Docket Item #2
BZA Case #2026-00008
Board of Zoning Appeals
July 22, 2026

ADDRESS: 2500 DEWITT AVENUE
ZONE: R-2-5/RESIDENTIAL
APPLICANT: GEOFF JACOBI & ANDREA DEFEITAS KIRK

ISSUE: Variance to allow an after-the-fact pergola to remain in the vision clearance area.

Figure 2: Proposed Vision Clearance Area

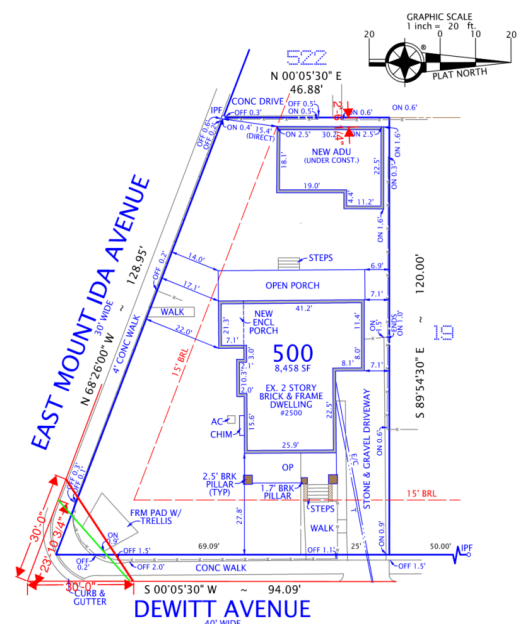
The property is a large complying corner lot with ample area in both front yards to construct a pergola outside of the vision clearance area. The Zoning Ordinance would permit this pergola in any of the required yards, which would allow is to placed somewhere on the property outside of the vision clearance area. The request for a variance from the vision clearance requirement is not a reasonable deviation from the Zoning Ordinance requirement related to structures not being placed in the vision clearance..

Strict application of the Zoning Ordinance would not restrict the use of the property. The applicants could relocate the pergola outside of the vision clearance area and keep the structure within the required primary or secondary front yard.

The requested variance to have an accessory structure within the vision clearance requirement is contrary to the ordinance. The intent of the vision clearance requirement is to ensure safety of travel by requiring openness at the intersection of two streets for increased visibility. The pergola creates sight distance challenges for drivers and pedestrians along the two narrow and intersecting streets. While the structure itself is mostly open, it is likely to become a gathering place or a place for outdoor furniture which would further reduce visibility. The granting of this variance would reduce the openness at the corner of Dewitt Avenue and East Mount Ida Avenue, thus potentially reducing the safety of travel at this intersection.

The strict application of the Zoning Ordinance would not unreasonably restrict the utilization of the property as the ordinance currently allows pergolas within all required yards. The pergola can be relocated out of the vision clearance in any other yard on the lot.

The property was likely acquired in good faith. The hardship was created by the applicants, as the pergola could have been constructed outside of the vision clearance area and in allowed within any required yard due to the structure having no required setbacks. This is due to the structure complying with the permit obstruction section of the Zoning Ordinance 7-202(A)(5).

The reduction in the required vision clearance would be detrimental to nearby properties because it will reduce visibility and travel safety.

If the Board decides to grant the requested variance, staff recommends a condition that the pergola must remain open on the sides and the roof must remain 80% open as constructed. The project is subject to compliance with all applicable code requirements, ordinances, and recommended conditions found in the department’s comments. The variance must also be recorded with the deed of the property in the City’s Land Records Office prior to the release of the building permit.
